TYPES O AND ON CARRIER TELEPHONE SYSTEMS — TERMINALS AND JUNCTIONS

CHANNEL UNIT LINE-UP — TRANSMITTING

COMPRESSOR OUTPUT

COMPRESSOR OUTPUT

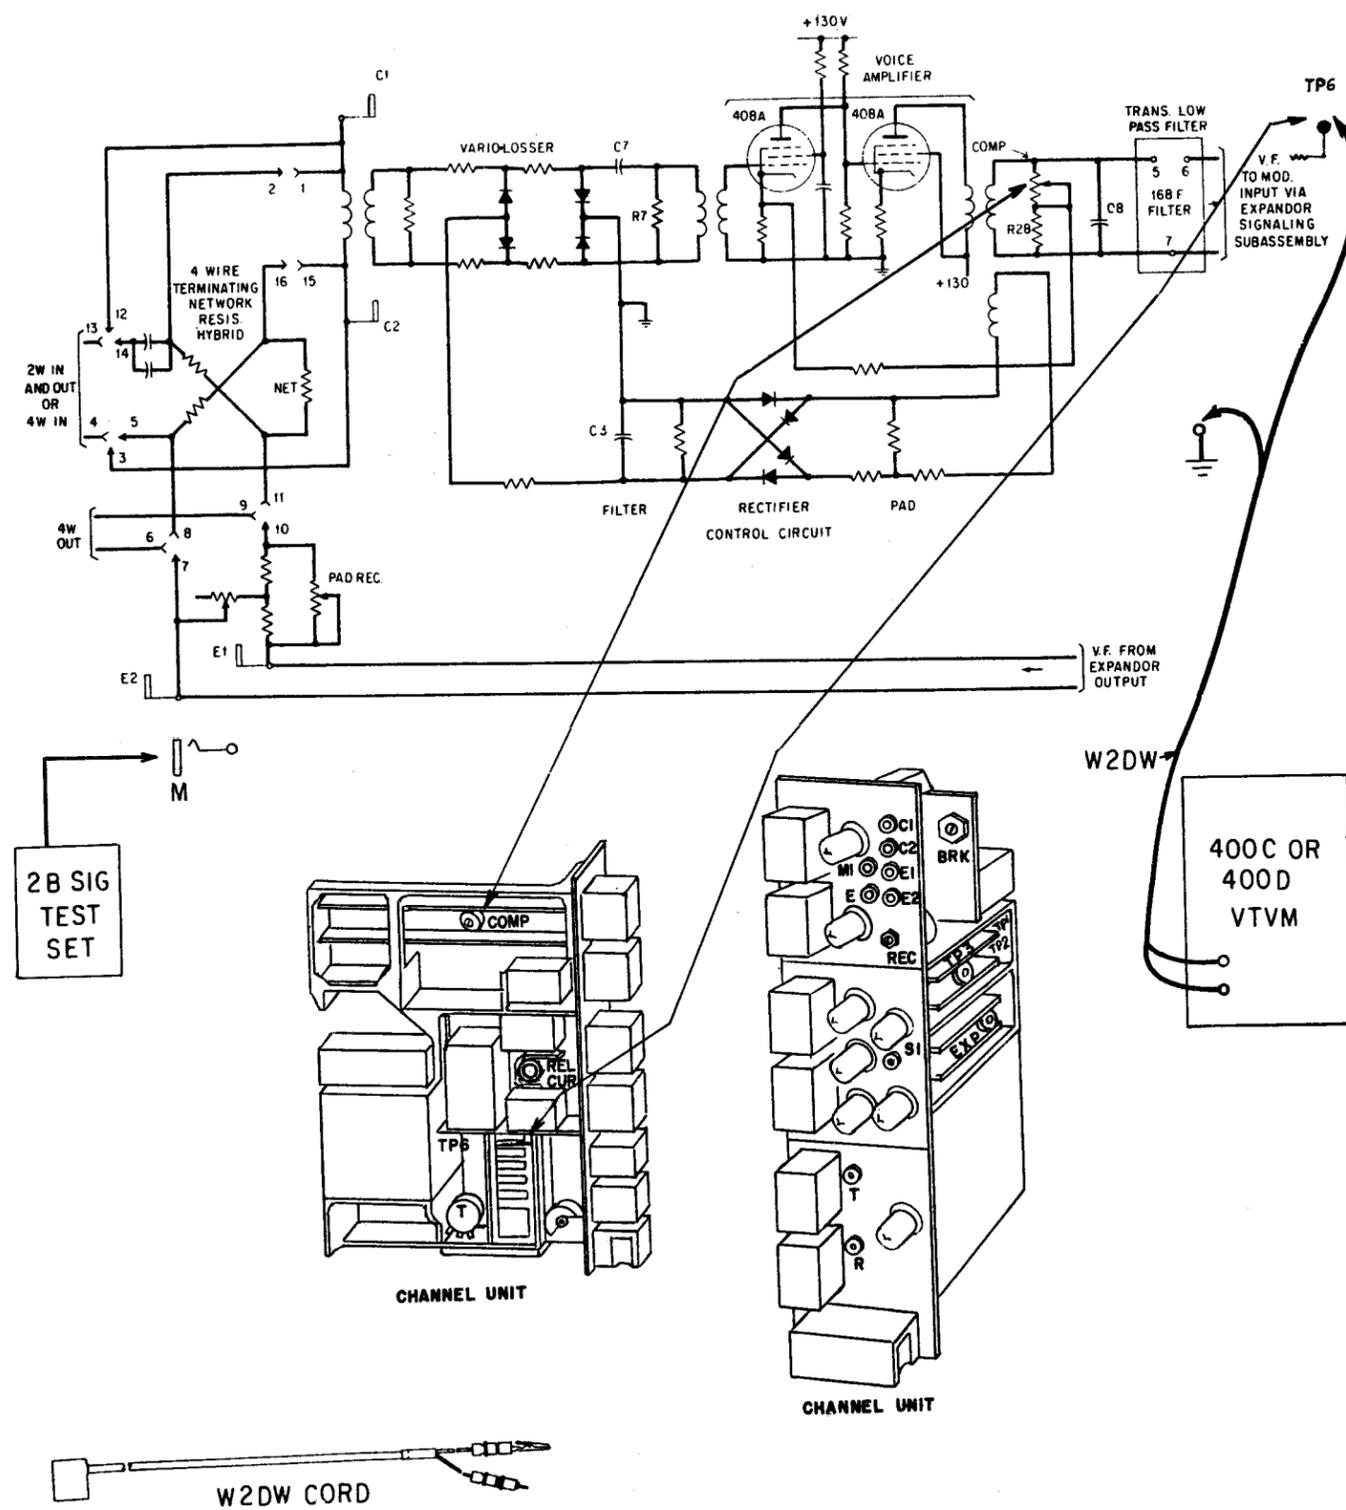
This section is reissued to relax the maximum compressor output requirement.

STEP	PROCEDURE
1	The channel under test must be out of service and inserted in the test stand.
2	With the 2B signaling test set, put an OFF-HOOK condition on the channel under test. If used at the patching bay, connect the L jack of the 2B test set to SIG L jack of patch bay. If used at the channel unit test stand, connect the M jack of the 2B test set to the M jack of the test stand, using a 2P1D cord. Operate the TWD L key of the 2B test set to OFF HK.
3	Send 1000 cycles at −16 db in the VF IN jack.
4	Connect the 400C or D VTVM to the TP6 terminal on the channel unit and ground.
5	Adjust the COMP potentiometer for a maximum reading.
	Requirement: At least +9.5 db.
